V2500-A5 SERIES PROPULSION SYSTEM NON-MODIFICATION SERVICE BULLETIN

This document transmits the Initial Issue of Non-Modification Service Bulletin V2500-ENG-74-0006.

NON-MODIFICATION SERVICE BULLETIN – IGNITION – INSTALLATION REQUIREMENTS FOR IGNITER
PLUGS OF SERVICE BULLETIN V2500-ENG-70-1003 STANDARD

Installation of the Cooling Shroud
Figure 1

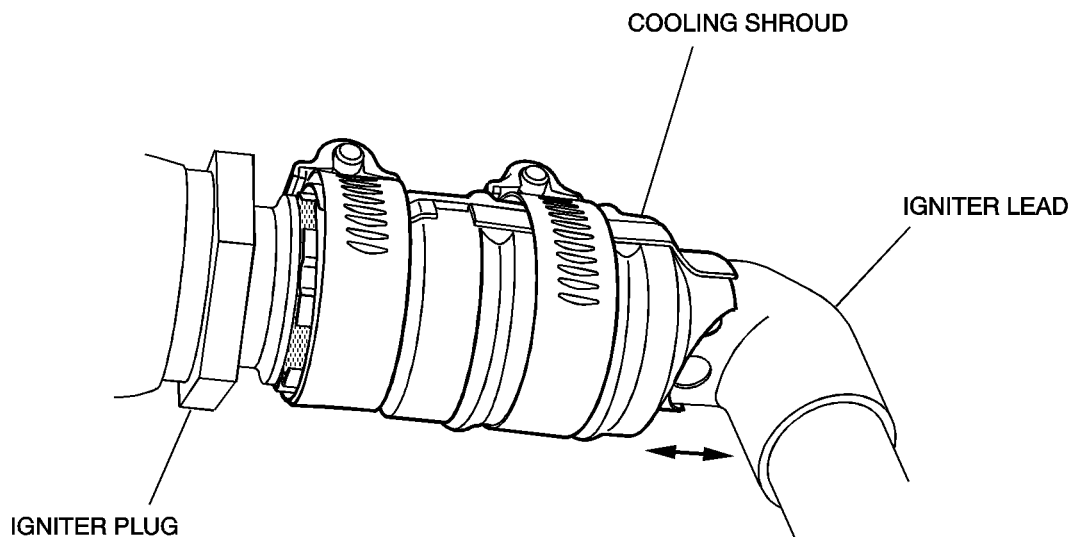
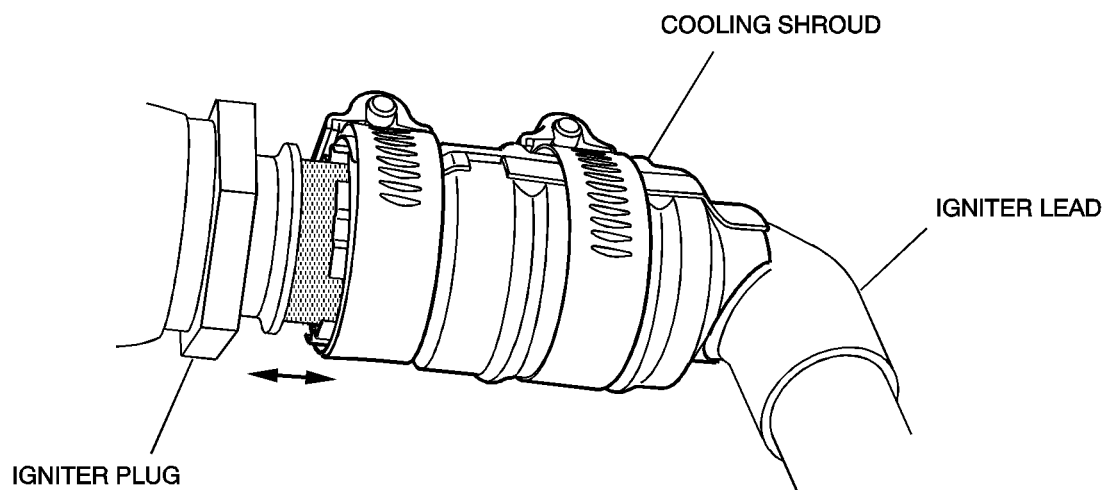
(a) If an igniter plug has to be replaced ensure the correct installation of the cooling shrouds (Refer to Figure 1 and the CAUTION below)

NOTE: Figure 1 shows the installation of the NGK igniter plug, the current shroud standard together with the new ignition lead of Service Bulletin V2500-ENG-70-1004.

CAUTION: INSTALL THE COOLING SHROUD AS CLOSE AS POSSIBLE TO THE INNER RADIUS OF THE IGNITION LEAD ELBOW. MAKE SURE THAT THE COOLING AIR EXIT HOLES ARE NOT BLOCKED AND FULLY COVERED BY THE HOLLOW PART OF THE COOLING SHROUD.
